Access Compliance Report

Public Rights-of-Way

(Curb Ramps)

Intersection ID: 2815	Main Street: BABERTON_CT	Cross Street: DUNOON_LN	Location: W
ADA ID: C12F72F8EA4E	Ramp Type: PerpDiag	Initial Pass/Fail: Fail	Overall Compliance: No
Codes/Mitigation Info/Possible Solution		Field Measurements/Component Compliance	
Severity Score: 33.75

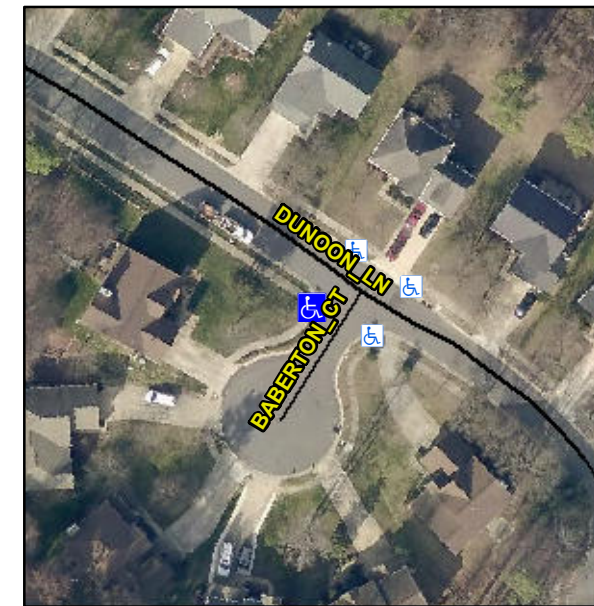
Not Found, R304.5.1, R304.2.2, R304.5.3

Compliance	Description	Data	Compliance	Description	Data
N/A	Ramp Length (in)	30.0	No	Ramp Slope (%)	8.6
No	Ramp Width (in)	36.0	No	Ramp XSlope (%)	5.4
N/A	Flare Type LT	N/A	N/A	Flare Type RT	N/A
N/A	Flare Slope LT (%)	N/A	N/A	Flare Slope RT (%)	N/A
N/A	Flare Traversable LT?	N/A	N/A	Flare Traversable RT?	N/A
N/A	Landing Length (in)	N/A	N/A	DWS Provided?	N/A
N/A	Landing Width (in)	N/A	N/A	DWS Contrast?	N/A
N/A	Landing Slope (%)	N/A	N/A	DWS Length (in)	N/A
N/A	Landing X Slope (%)	N/A	N/A	DWS Full Width?	N/A
N/A	Landing Curb? (Y/N)	N/A	N/A	DWS Offset (in)	N/A
N/A	Shared Landing?	N/A			
N/A	Gutter Ponding?	N/A	N/A	Gutter Slope (%)	N/A
N/A	Gutter Lip Ht (in)	N/A	N/A	Gutter X Slope (%)	N/A
N/A	Painted X Walk1?	No	N/A	Painted X Walk2?	No
	X Walk 1 Direction	To SE		X Walk 2 Direction	To NE
N/A	X Walk 1 Width (in)	N/A	N/A	X Walk 2 Width (in)	N/A
	X Walk 1 Slope (%)	0.1		X Walk 2 Slope (%)	5.2
	X Walk 1 X Slope (%)	9.0		X Walk 2 X Slope (%)	0.7

Remove & Replace Curb Ramp With Two New Directional Ramps or Equivalent.
